Site Suitability Analysis – Engineering Rebuttal Report

Site in the Township of Middletown:

Block 1045, Lot 12 (490 Red Hill Road)

T&M Associates

Figure 1: Wastewater Management Plan Viewer (Red Hill Road Site)

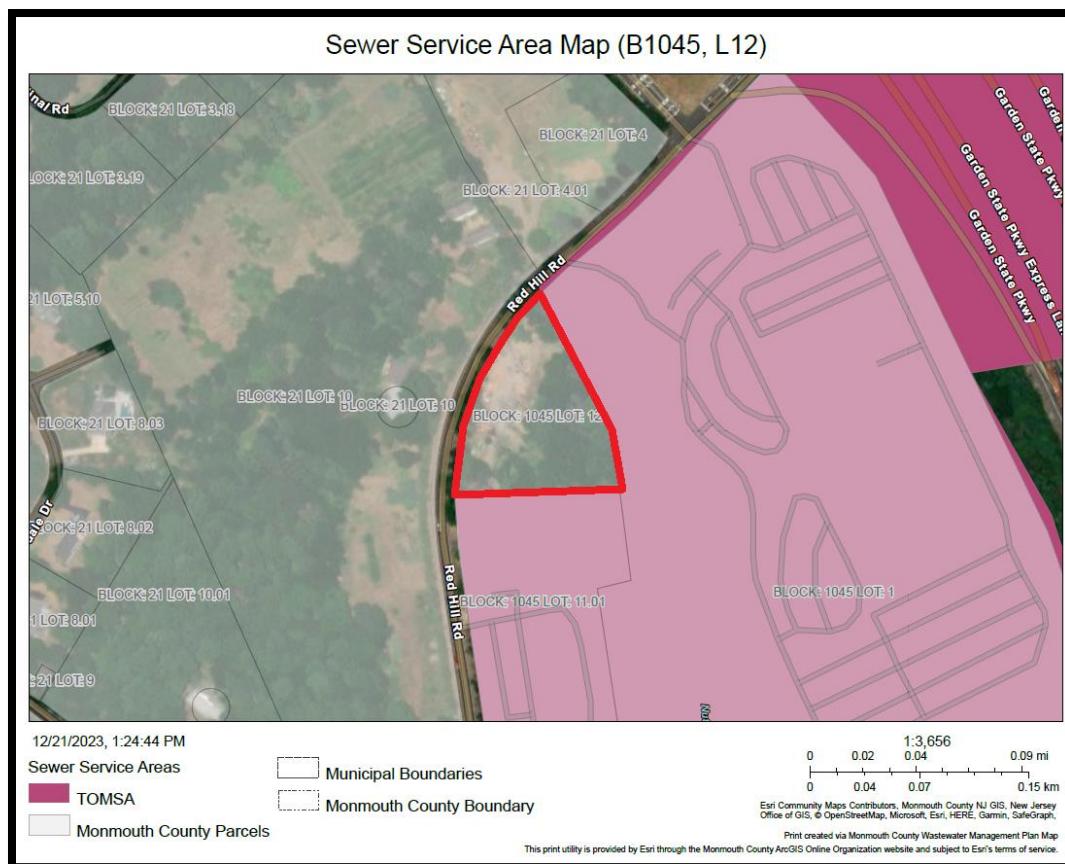
As can be seen from Figure 1 below, based on our review of the GIS data provided by the NJDEP and Monmouth County, the Red Hill Road Site is located outside of the sanitary sewer service area, which the Township of Middletown Sewerage Authority (TOMSA) operates within. The Developer cannot develop the site with high density multi-family housing, without approval from TOMSA, Monmouth County and the NJDEP to amend the current Monmouth County Water Quality Management Plan and include the property lot in TOMSA's current service area. NJDEP may not issue the amendment due to reasons discussed later in this report. **It should be noted that the Developer has obtained a "Will Serve Letter" from TOMSA for the West Nut Swamp Road Site, but has not obtained one for the Red Hill Road Site, likely because the site is not in the sewer service area.**

Figure 2: NearMap aerial imagery dated July 13, 2019 showing the site prior to 2020 tree clearing.

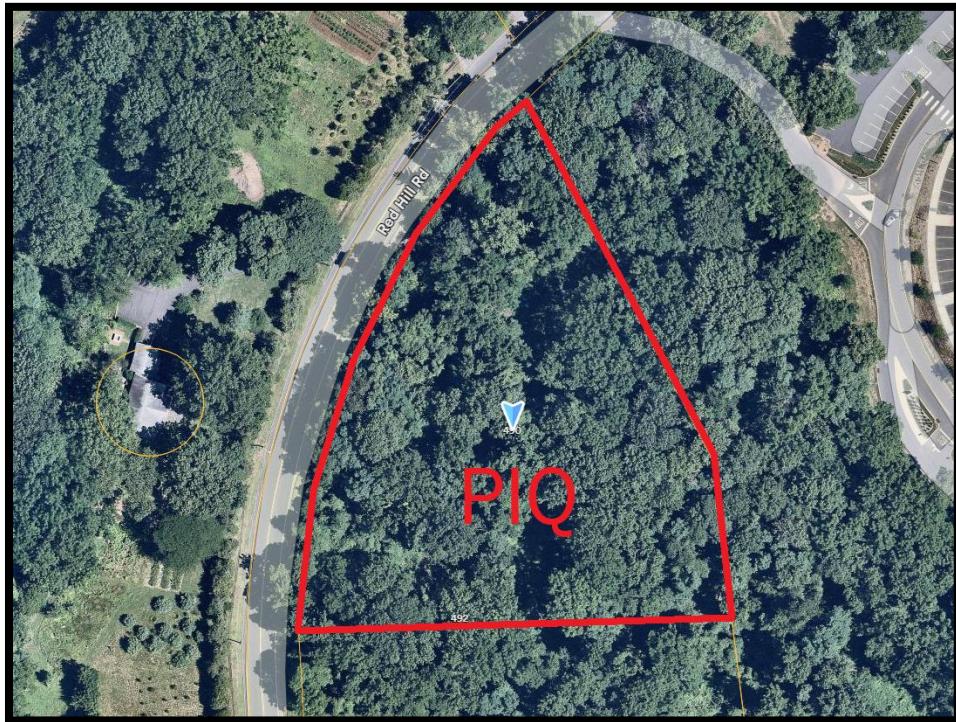
- **Based upon our review of NearMap aerial imagery (Figure 2), a significant amount of tree clearing took place onsite around 2020. If the property owner cleared these trees without the necessary regulatory approvals pursuant to §540-534, the overall tree clearing percentage would increase to the range of 55-65 % as a result of this unlawful activity.**

EXHIBIT 1

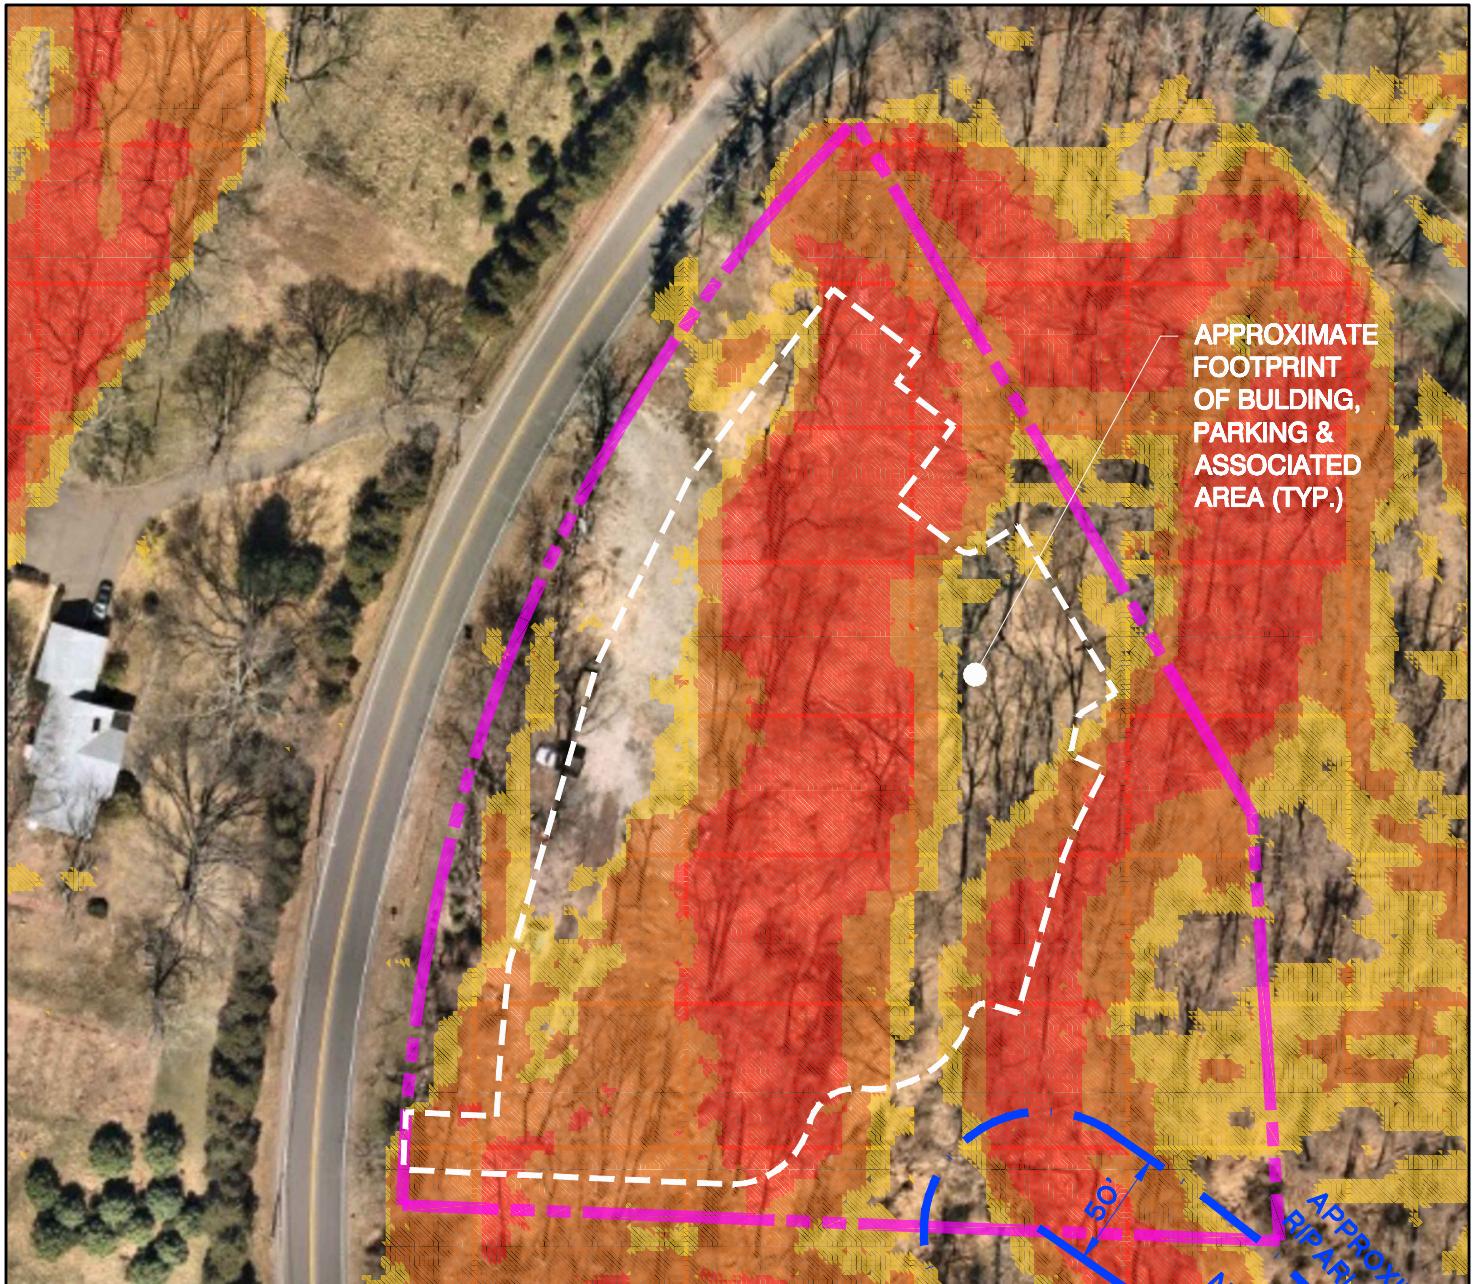
Based on this office’s review of topographic data, more than 75% of the property is situated on slopes greater than 10%. We estimate the proposed Development Concept will disturb over 56% of the steep slopes greater than 10%, 39% of slopes between 10-15%, 52% of Class II Critical Areas (15-25% slope) and 68% of Class I Critical Areas (>25%) onsite. Many other recent Planning Board approval have been able to demonstrate a reasonable use of the property, while minimizing disturbances to these areas. It does not appear that the Development Concept has made any such effort to minimize disturbance to these areas, and the likelihood that the Developer could minimize without reducing the scale of the development is unlikely. To both reduce the overall footprint of steep slopes disturbance and maintain the same proposed dwelling unit count, this would require the building height to be increased in terms of both feet and stories, which will exacerbate the visual impact and availability of air light and open space to neighboring properties.

PROPOSED TREE CLEARING EXHIBIT
"RED HILL ROAD SITE"
BLOCK 1045, LOT 12
MIDDLETOWN TOWNSHIP, MONMOUTH COUNTY, NJ

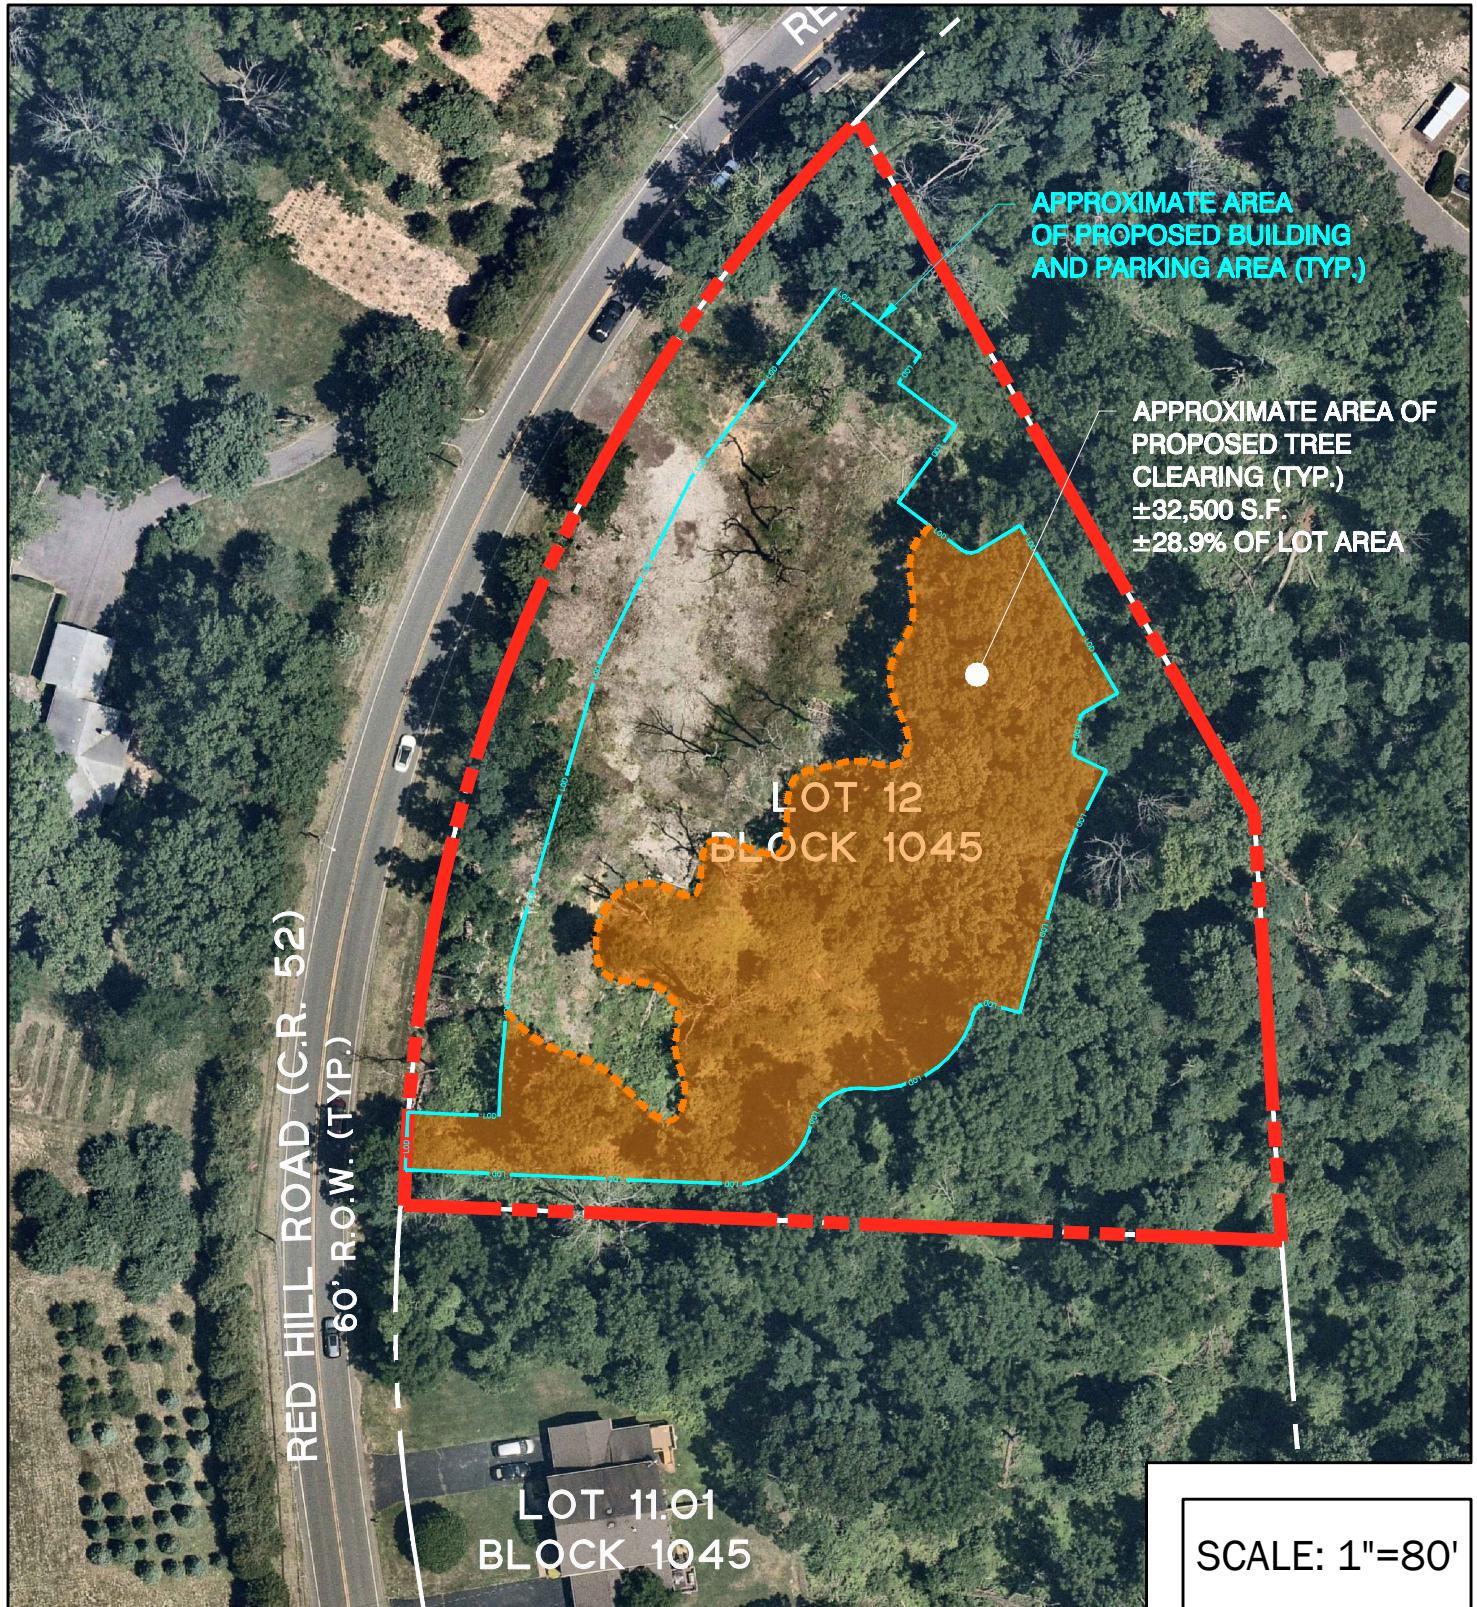
- **The analysis is based upon a review of Aerial Imagery and a site visit by this office. The limits of existing trees could expand based on an actual physical tree survey.**

MIDDLETOWN TOWNSHIP DESIGN FIRE TRUCK
CIRCULATION EXHIBIT #1
"RED HILL ROAD SITE"
BLOCK 1045, LOT 12
MIDDLETOWN TOWNSHIP, MONMOUTH COUNTY, NJ

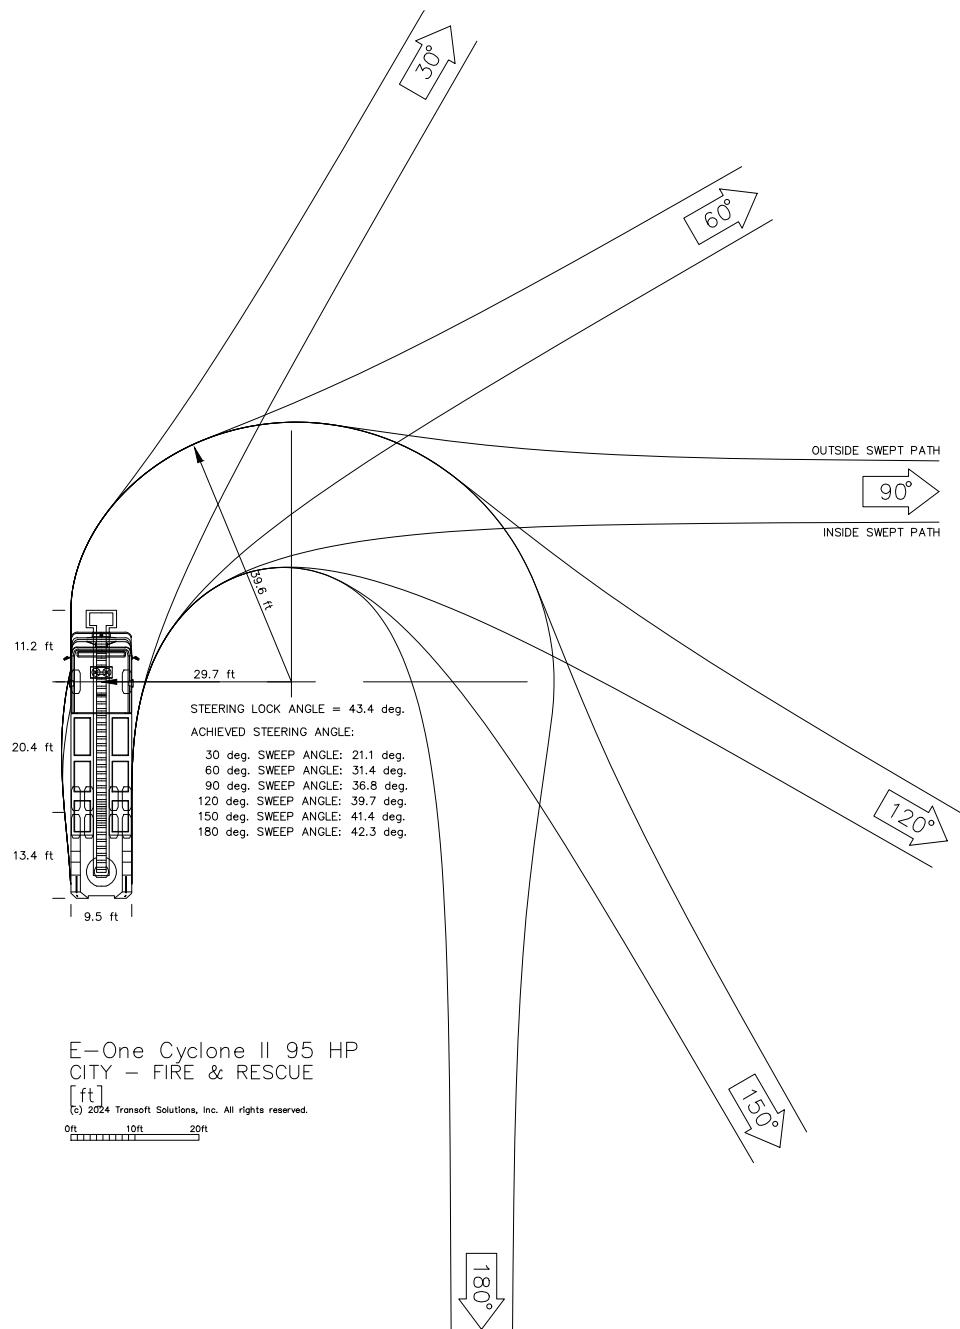
As part of any application to the Township of Middletown Planning or Zoning Board for Site Plan approval, the Developer would be required to provide Circulation Plans demonstrating that the proposed site layout provides adequate circulation for various design vehicles anticipated to frequent the site. This would typically include a Circulation Plan for the Middletown Township Fire Truck Design Vehicle (E-One 95 Platform Cyclone II Chassis with Aerial Ladder). **T&M has prepared a Circulation Exhibit for the Middletown Township Fire Truck Design Vehicle (Exhibit 4) to assess adequacy of the current site layout for emergency vehicles.** As can be seen, the Design Vehicle cannot freely circulate the site without exceeding the bounds of the proposed circulation drive aisles, particularly where the main site driveway transitions to the lower parking area, and where the main site driveway transitions to Red Hill Road. In both locations, as the Design Vehicle egresses the lower parking area and also the site driveway, the Design Vehicle departs the proposed limits of the driveway aisles, which is an unsafe condition.

USDA SOIL MAPPING EXHIBIT
"RED HILL ROAD SITE"
BLOCK 1045, LOT 12
MIDDLETOWN TOWNSHIP, MONMOUTH COUNTY, NJ

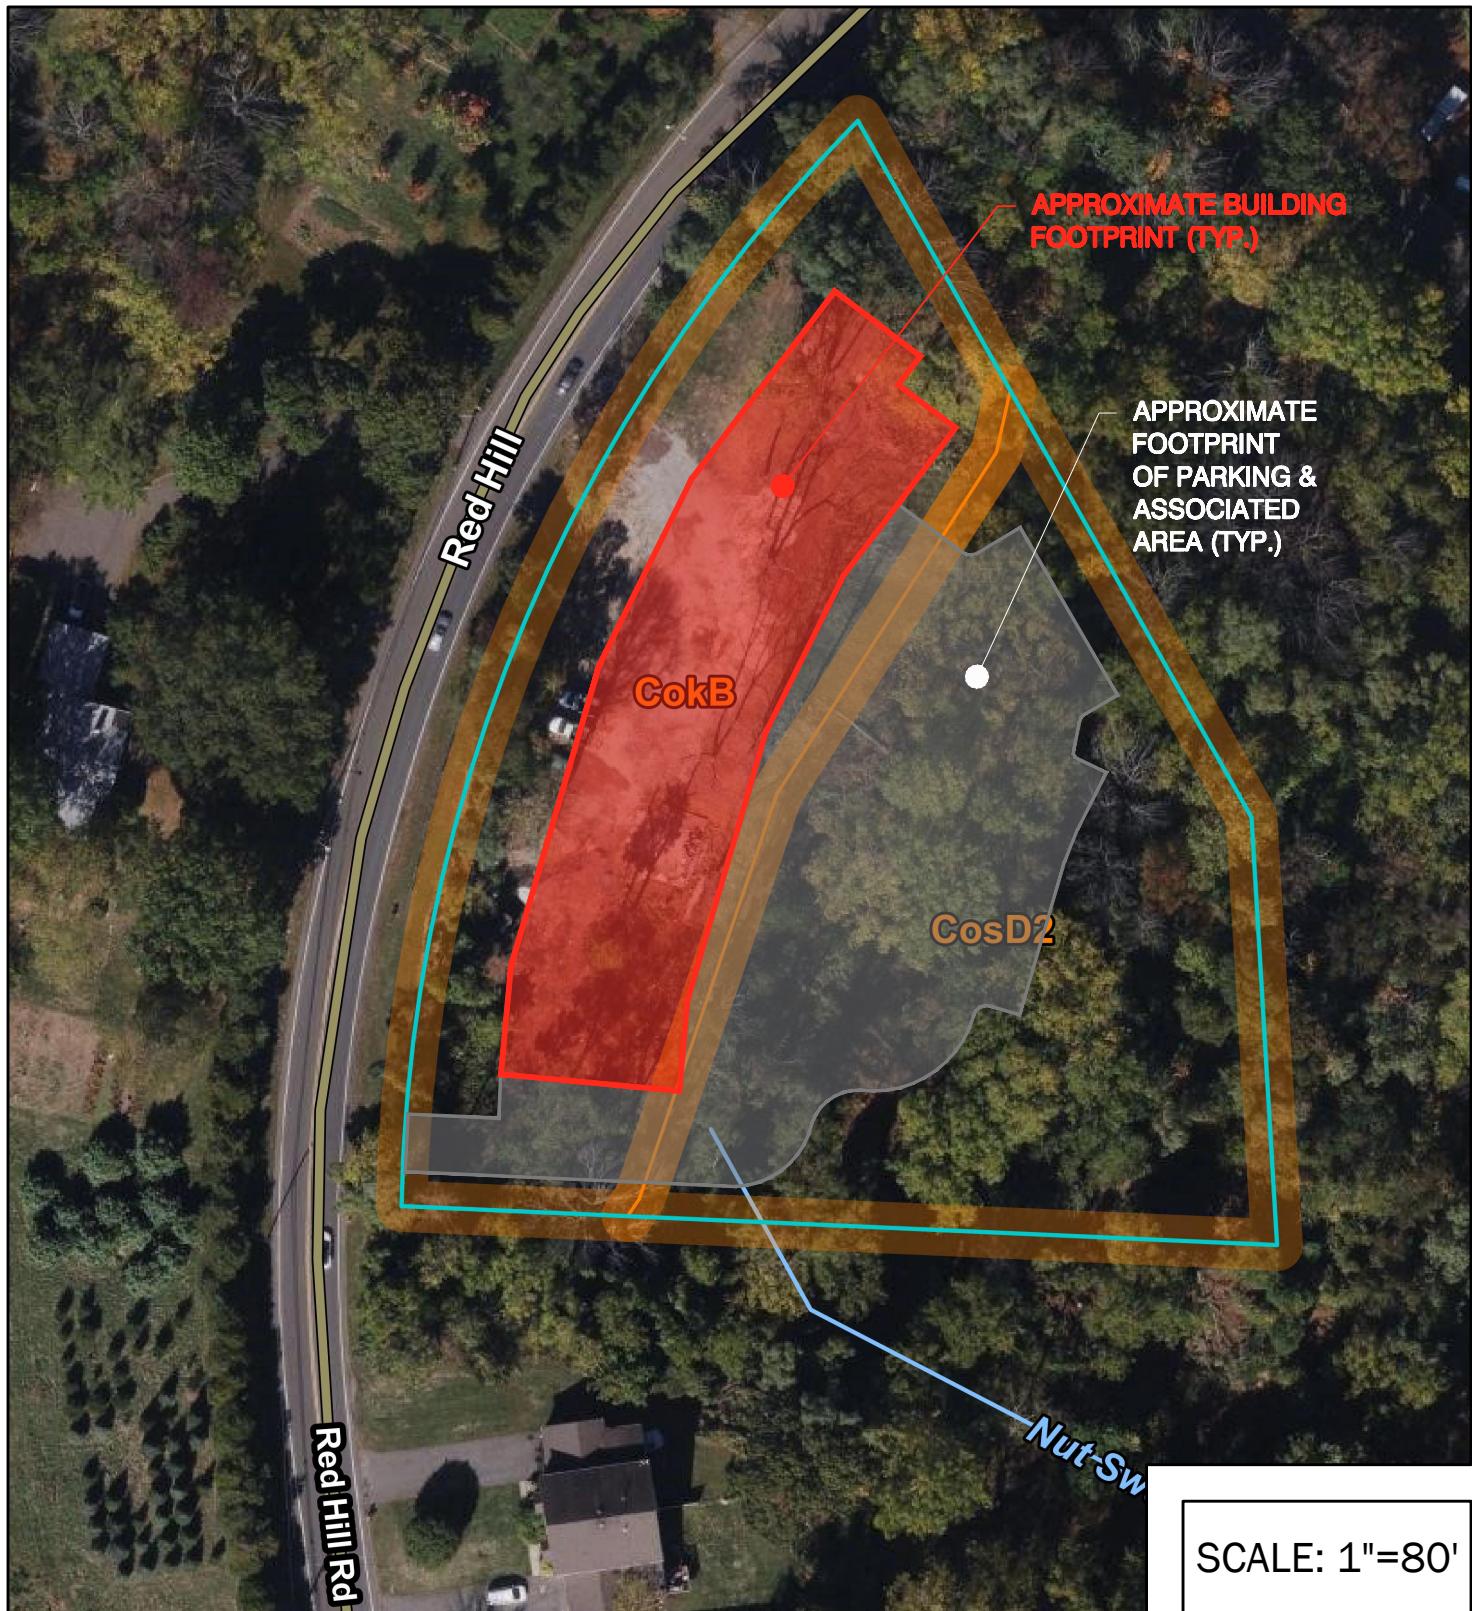
- The Development Concept does not demonstrate compliance with Township's and NJDEP stormwater management regulations. The plans do not provide adequate space for above ground BMPs nor delineate the location of any underground BMPs. Implementation of underground GI BMPs may not be feasible given depth to ESHWT and restrictive soils based on USDA Soil Mapping., without significant modification to the Development Concept.
